## COORS CORRIDOR PLAN

### Meeting 3

Theme: View Preservation Regulations and General Design Regulations

### View Preservation Regulations

Revised Figure - Visual Mass

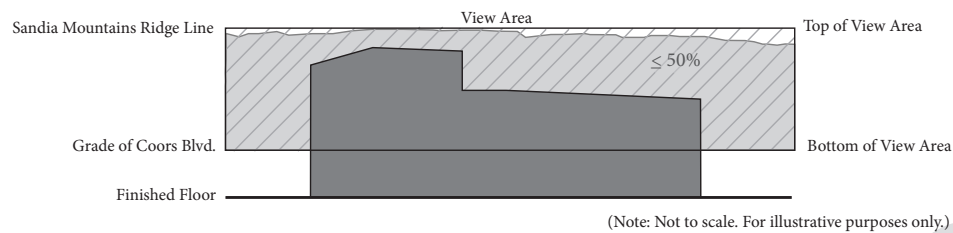
~~i) No more than 30% of an individual structure's width horizontal expanse, as seen in the view area, shall penetrate above the horizontal view plane as seen in the view area.~~

i) The visual mass of the structure(s) on the project site shall obscure no more than 50% of the view frame area or the view area depending on the number of structures and application type (see definition of view area).

Figure 1-5: View Frame

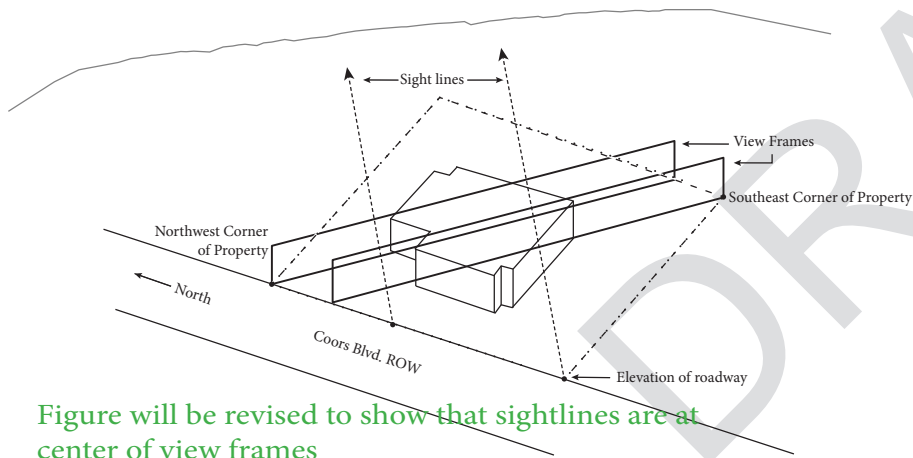
Figure will be revised to show that sightlines are at center of view frames
